3/4.9.6 REFUELING PLATFORM

WASHINGTON NUCLEAR - UNIT 2 3/4 9-8

REQUEST FOR AMENDMENT TO TECHNICAL SPECIFICATION 4.9.6, REFUELING PLATFORM LOAD LIMITS

Figure 2

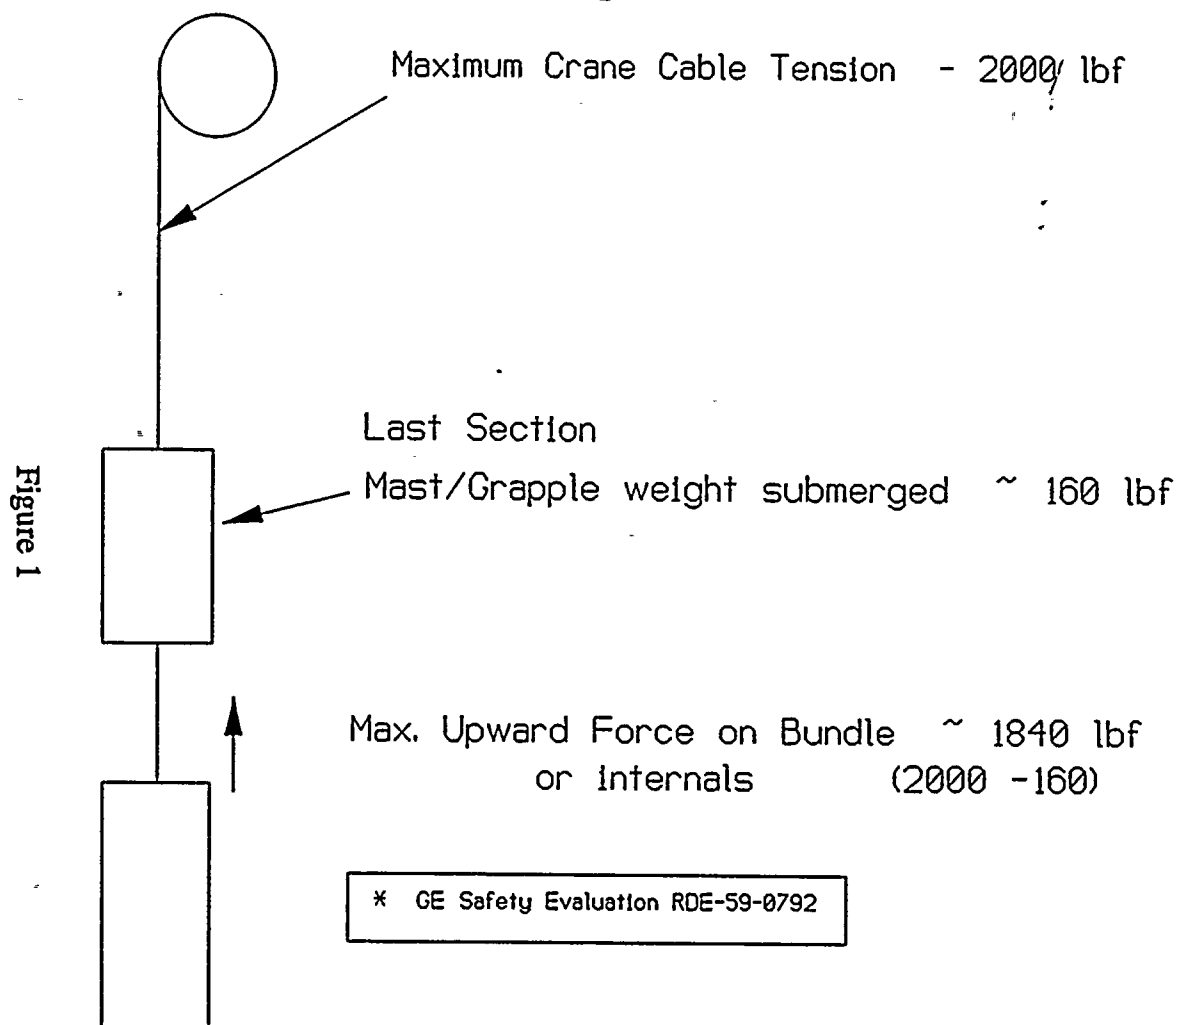
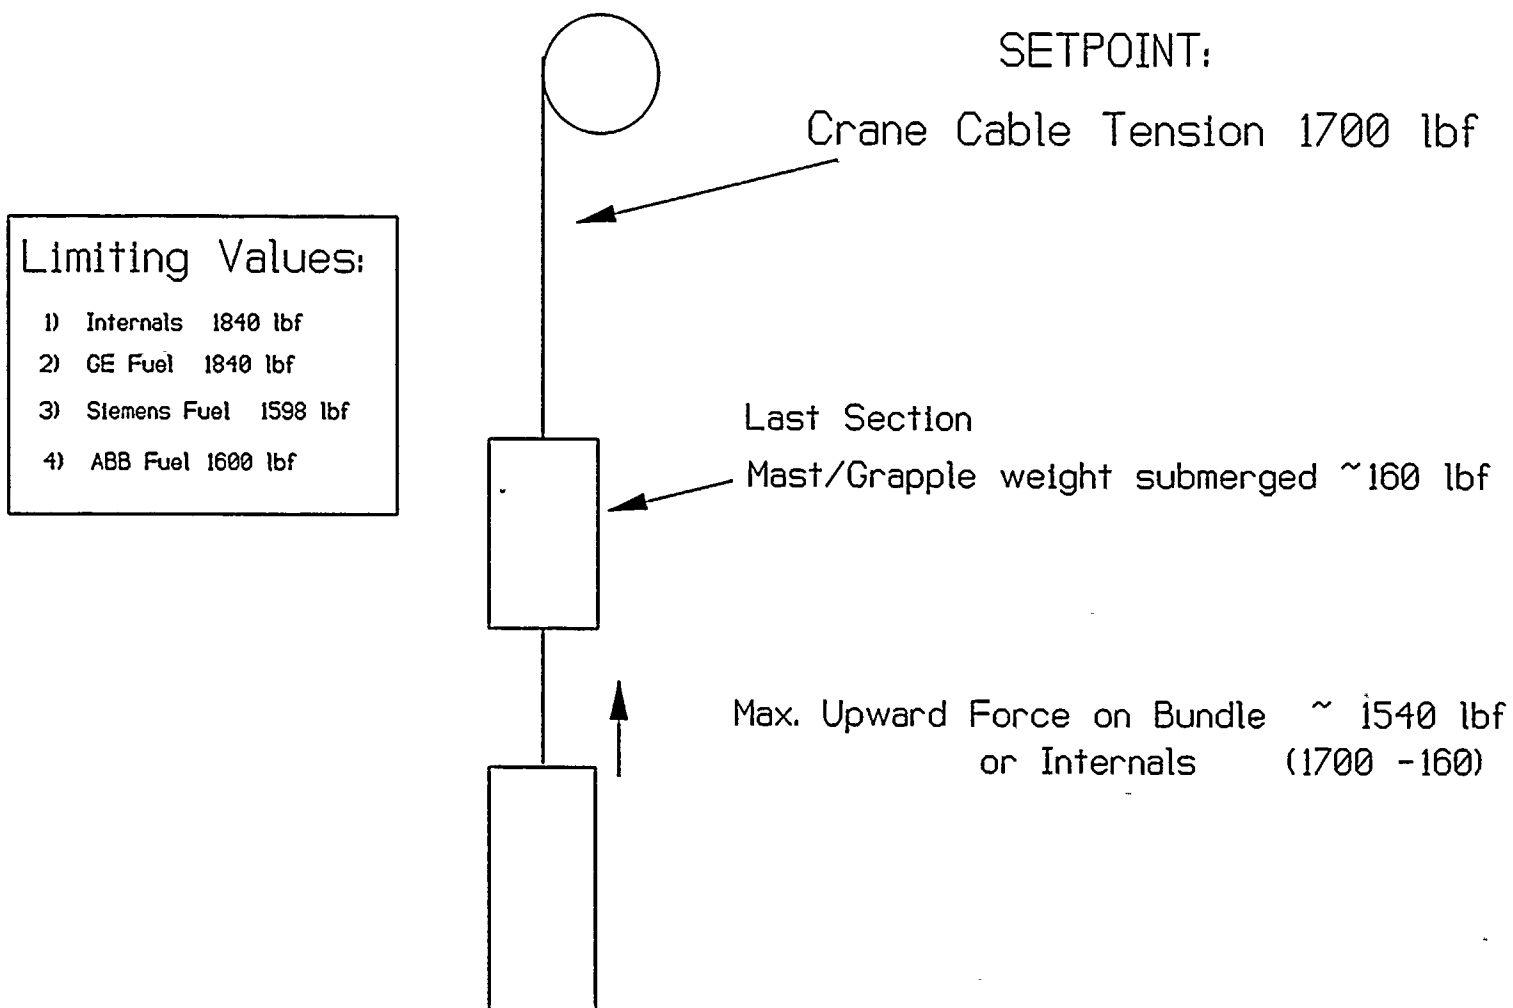
For a main hoist overload cutoff Technical Specification setpoint of 1700 lbf, electrical calculation EI-02-93-1200 ensures that instrument accuracy, setpoint drift, reel tension, and other pertinent factors are addressed such that the main hoist overload cutoff will trip before or at 1700 lbf. For this 1700 lbf setpoint, the maximum upward force on the reactor internals or a fuel assembly will be 1700 lbf minus the submerged weight of the last mast section and the grapple (approximately 160 lbs submerged or 180 lbs dry weight) or approximately 1540 lbf, see Figure 2. This effective force of approximately 1540 lbf is less than the limiting values for the vessel internals or any type of fuel assembly.

The Supply System notes that in the discussion in Item 1 above, and in Figures 1 and 2, the limiting parameters are the forces (lbf) applied to a hung fuel assembly and/or the vessel internals. The free weight of any type fuel bundle (dry or submerged) plus the last mast section and grapple weights, will be significantly less than the main hoist overload cutoff setpoint of 1700 lbf.
